**STATE SIGNIFICANT DEVELOPMENT
ASSESSMENT REPORT:
*Hornsby Ku-ring-gai Hospital
Redevelopment Stage 1
Palmerston Road, Hornsby
(SSD 5356)***

Director-General's
Environmental Assessment Report
Section 89H of the
Environmental Planning and Assessment Act 1979

June 2013

Figure 5: Southern Elevation (view from Burdett Street)

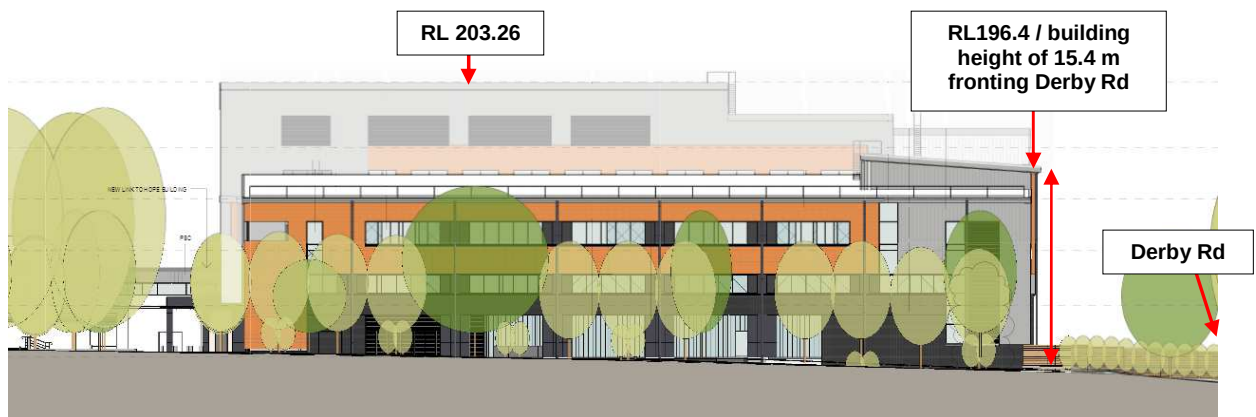
During assessment of the application, the department raised concern with the 2.7 metre setback from the southern Burdett Street boundary, as the height of the building in this location is 12.9 metres above existing ground level, which is significantly higher than existing low density residential development opposite the site. The setback also does not facilitate an adequate deep soil zone to allow vegetation of an appropriate scale to provide appropriate screening of a building of this size. The department requested that the applicant provide a greater setback along with an increased deep soil zone, in collaboration with additional plantings of mature vegetation to provide appropriate screening along Burdett Street.

During the assessment, the department met with the applicant and suggested that the applicant consider a number of further design amendments to reduce potential visual impacts of the building when viewed from Burdett Street. The suggested design amendments included recessing the Level 3 floor plate away from the southern face of the building and / or providing additional landscaping and screen planting along the council verge and within the 90 degree parking area opposite the building along Burdett Street. The applicant responded by identifying that the suggested design amendments to Level 3 would impact on the functionality of the building and would impact the entry lobby areas located below on Level 2 and Level 1. Notwithstanding, the applicant conceded that additional landscaping could be provided along the council verge to provide additional screening of the building, and that they would accept a condition to require the provision of addition landscaping in this location.

Notwithstanding, the applicant made modifications within the setback to the Burdett Street boundary to provide further capacity for mature vegetation and landscape screening of the building. The modifications included narrowing the concrete maintenance path along the buildings edge and supplementing the existing street trees which grow on the council verge with plantings of *Tristanopsis laurina* (Water Gum) within the setback. The additional trees are to be planted at regular intervals and will grow to a height of 6 metres and have a canopy spread of 4 to 6 metres, and are intended to provide year-round visual screening of the southern façade of the building.

The garden bed between the building and the existing street footpath was also increased slightly and varies in width between 1.74 and 1.95 metres, which takes greater advantage of the deep soil area and allows for more varied planting with a combination of groundcover, grasses, and shrubs to create a layered effect when viewed from Burdett Street.

Whilst the applicant's response has not included any increase in the setback, the design response of narrowing the concrete maintenance path, providing an expanded garden bed and additional plantings of mature vegetation is considered to assist in achieving the objective of improving visual buffering of the building from Burdett Street. The department also considers that the provision of additional landscaping within the council verge would further reduce potential visual impacts of the building when viewed from Burdett Street.
